5-DWT-0240

Straightness, Fa	tness, Parallel	Angle tolerance		Size tolerance		Material	A5052/A6061	Scale	2:1
	Length (mm)	Deviation	Angle (°)	Tolerance	Length (mm)	Tolerance	FUJIKURA FIBER OPTICS VIETNAM			
	0.5<,≤3	±0.2	≤10	±1°	0.5<,≤6	±0.05	Drawing nu	Drawing number: 5-DWT-0240		
	3<,≤6	±0.5	10<,≤50	±0°30'	6<,≤30	±0.1				
	>6		50<,≤120	±0°20'	30<,≤120	±0.15	Drawing na			
^0	±1	120<,≤400	±0°10'	120<,≤400	±0.2	1	BR5 Adap	ter King

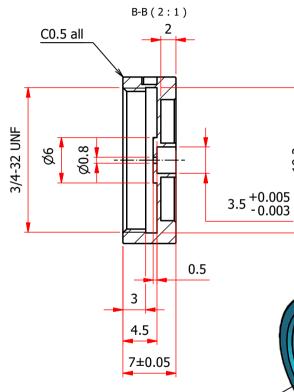
REVISION HISTORY												
ZONE	VER 5		Description	Design	Reason of change							
ZONE		Old content	New content	Design	ixeason of change							
		Material: A5052 Anodize Black Letter on front face	Material: A5052/A6061 Sand Blasting + Anodize Black Letter on round face	ThinhLT	Add more materials Add sand blasting Change letter position
